Holiday Inn Express

1748 Taft Street, Hollywood, FL

Proj. No. 19-23

Alexandra Guerrero, Principal Planner (aguerrero@hollywoodfl.org) 954-921-3471

FOURTH FLOOR PLAN

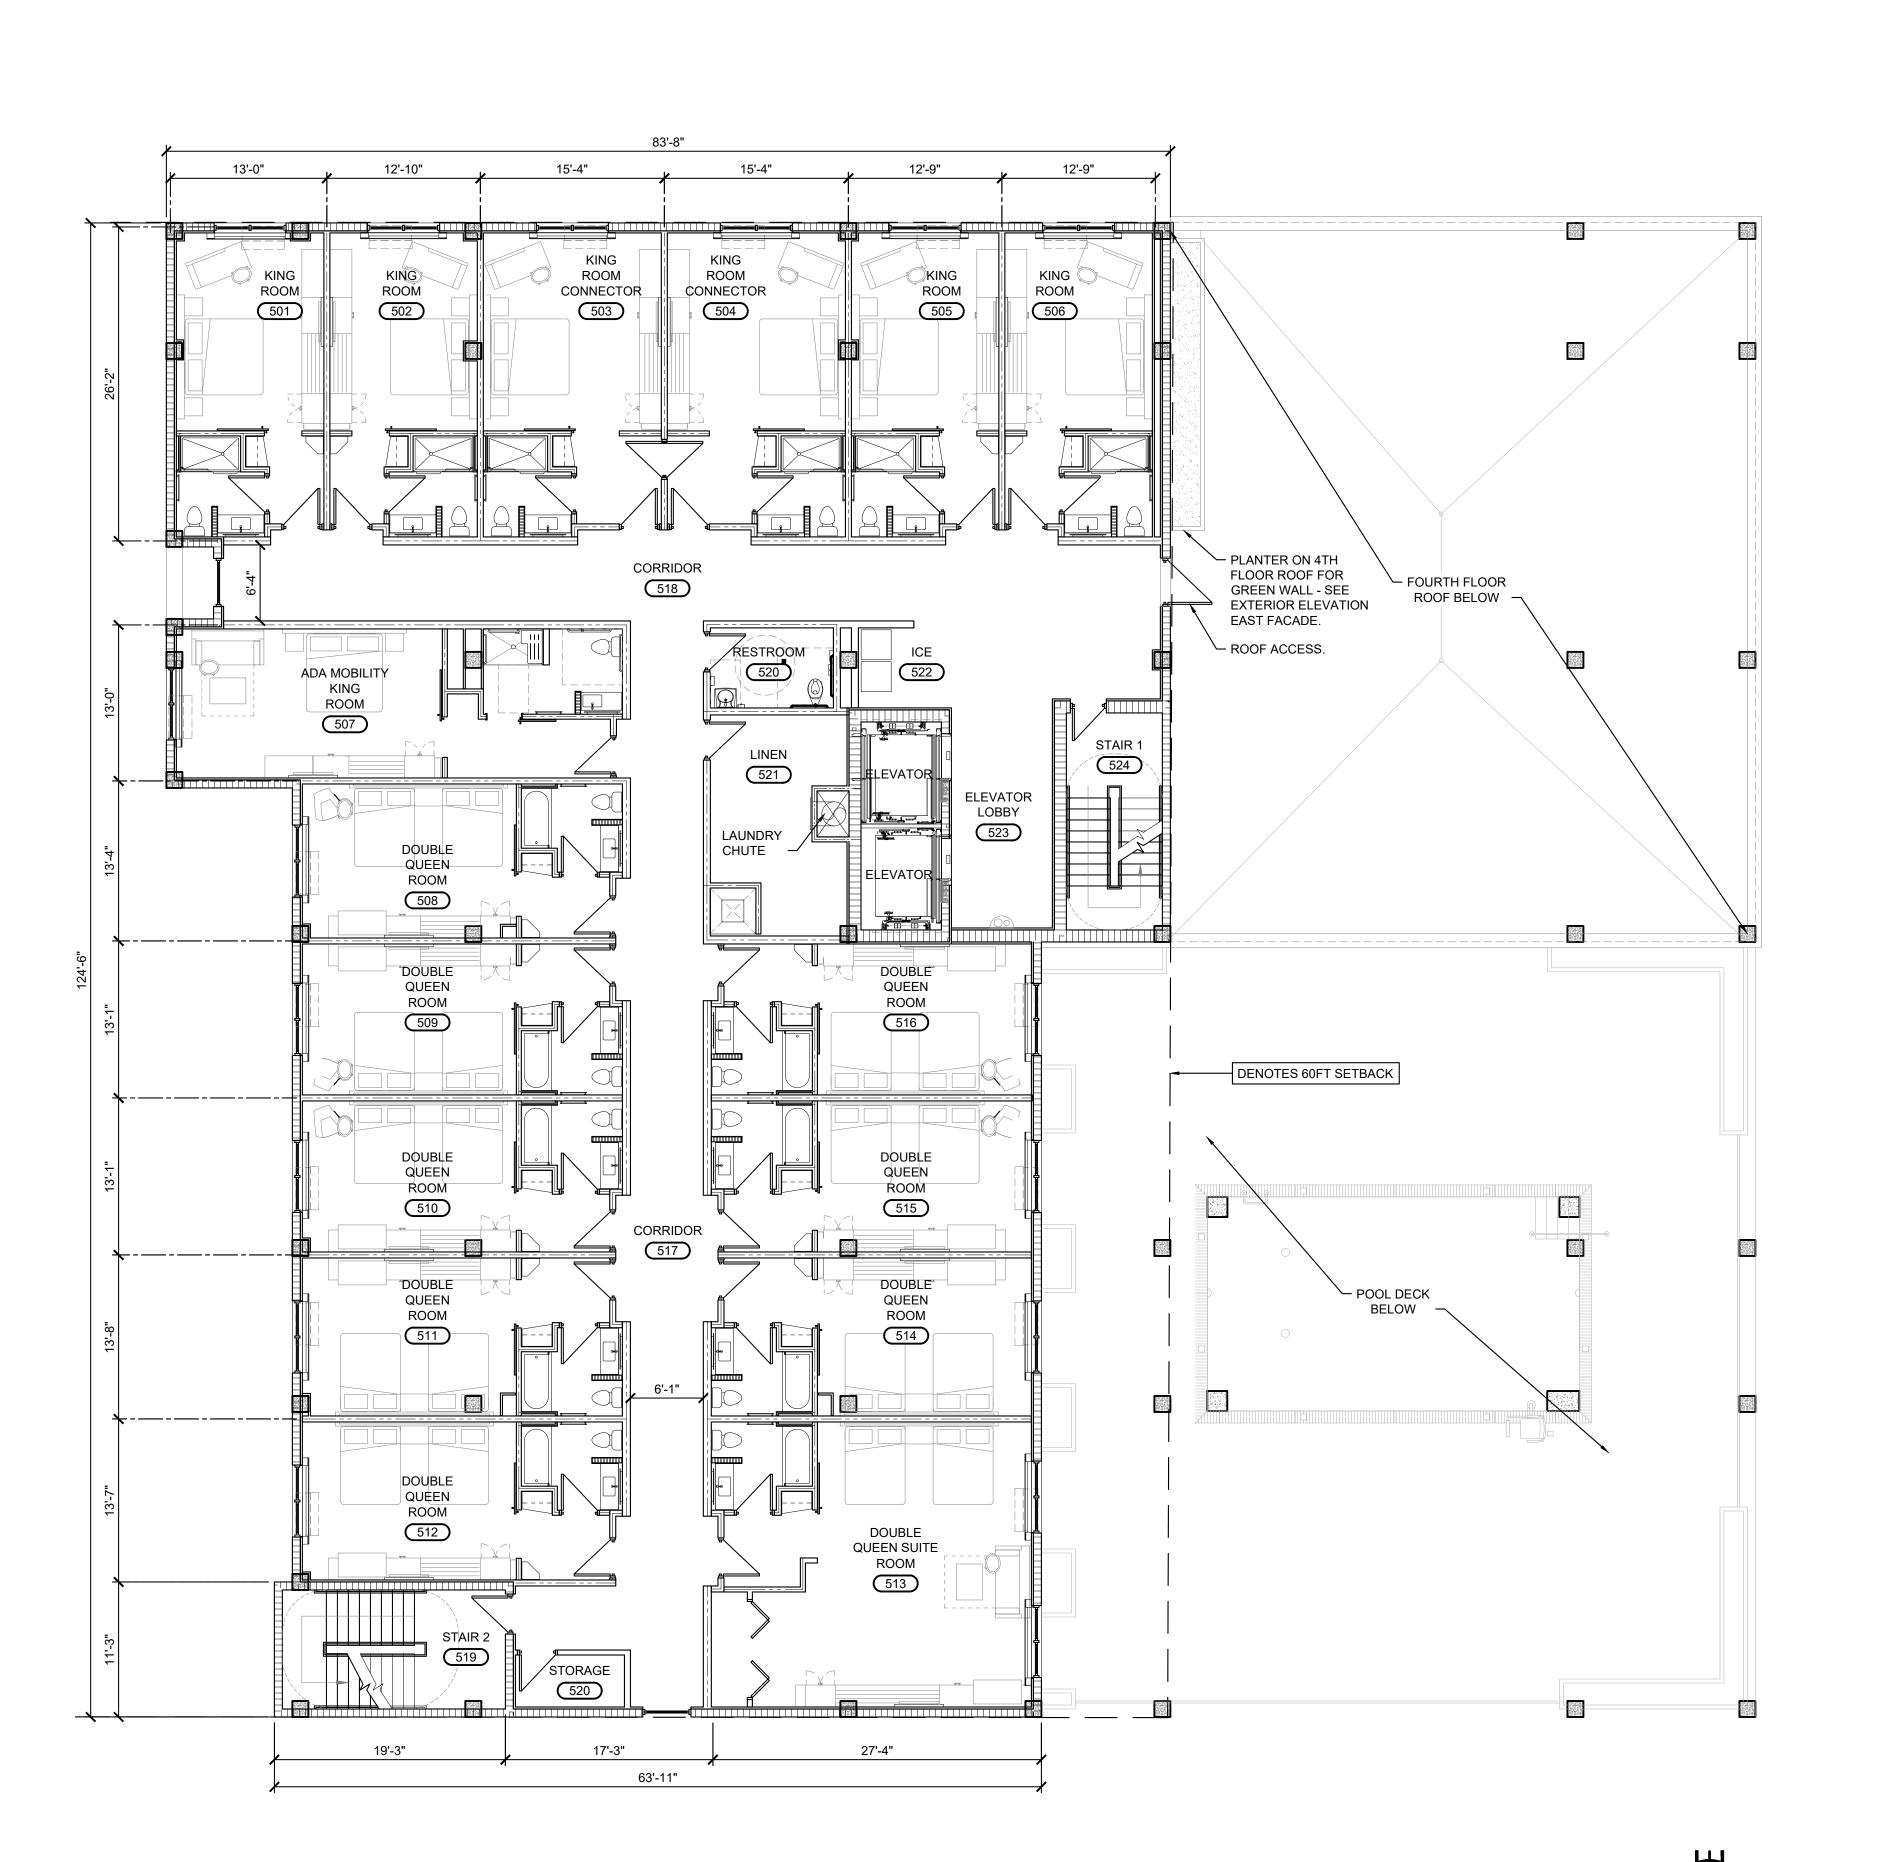
1. On floors 4 thru 8, correct the entry doors. Plans currently depict a wall in front of the doors.

Response: The plan has been adjusted (the 'wall' is a header from another layer).

BUILDING SECTIONS

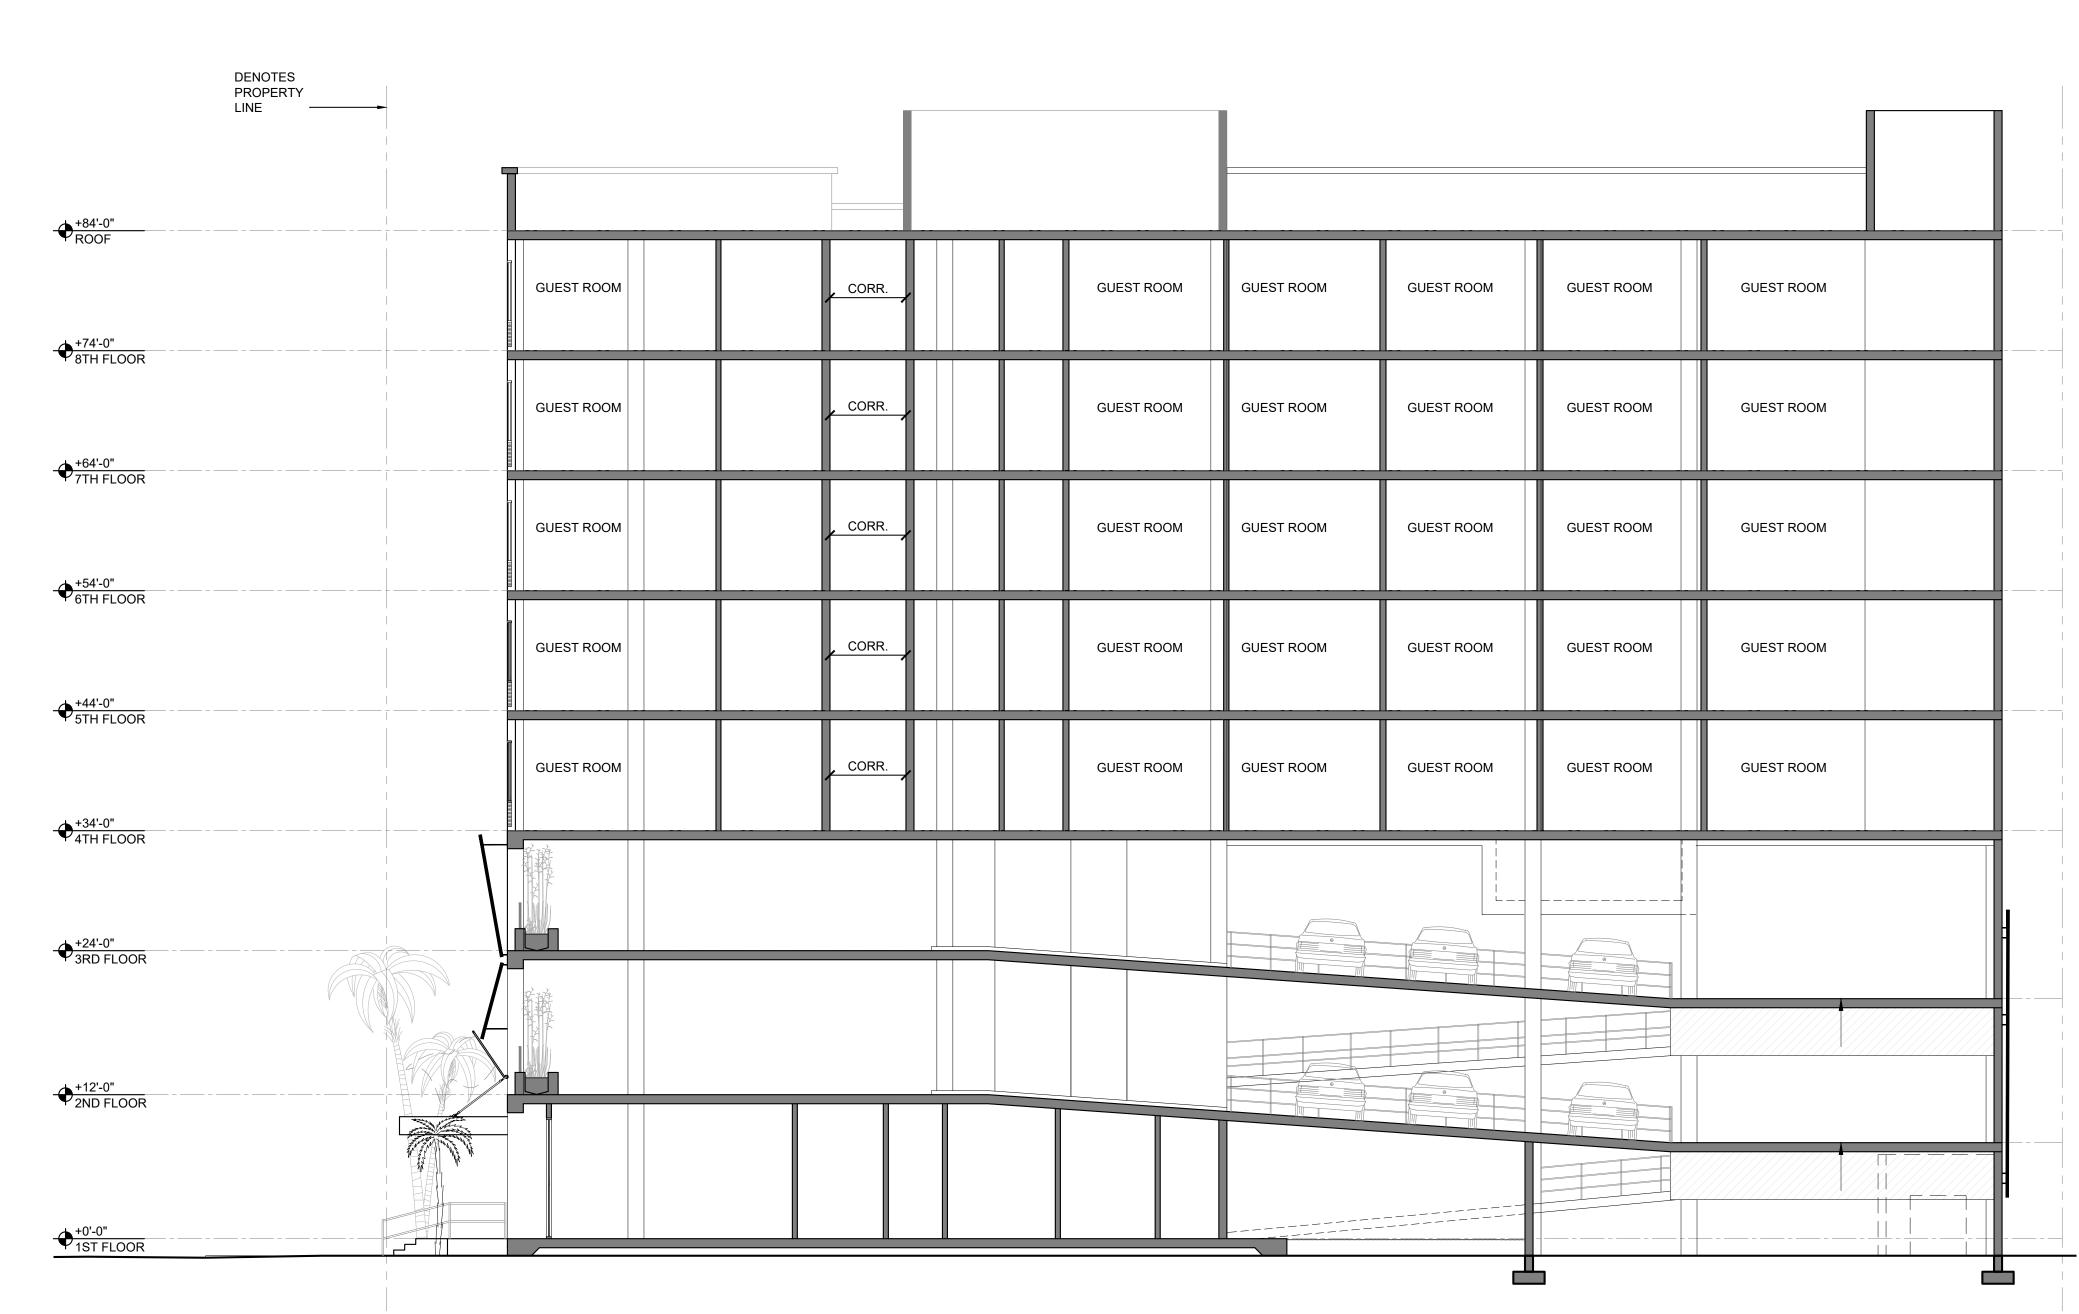
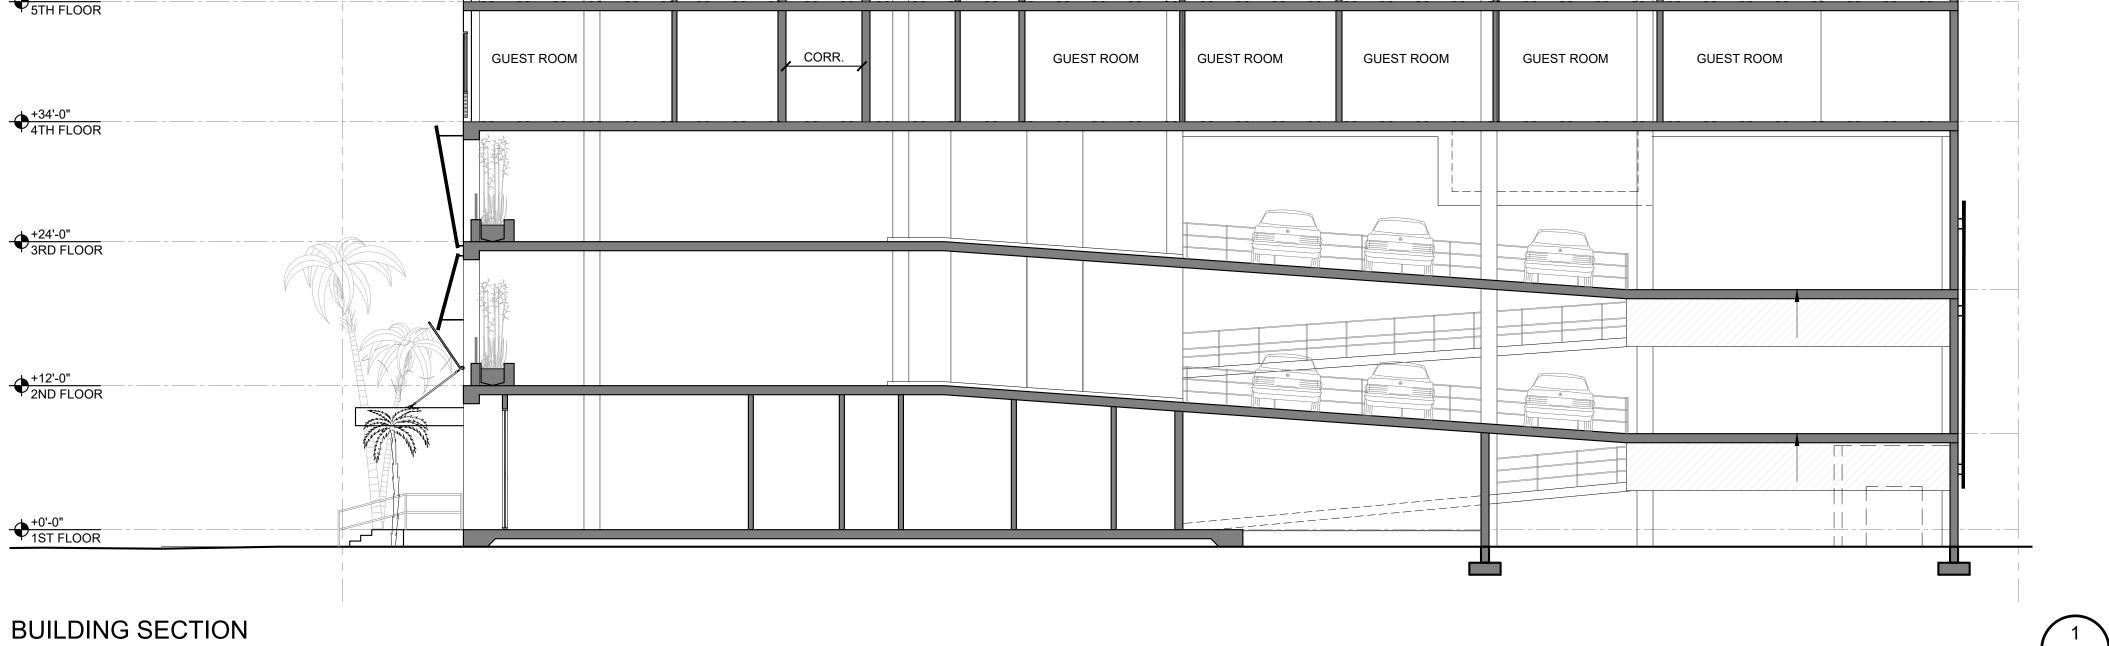
5. Provide cross-section details for the parking, drive aisles, proposed ramps, etc. Be sure to include ramps grading slopes.

Response: Preliminary building sections have been added to the package on Sheets A300 & A301, depicting the vehicular ramp slopes.
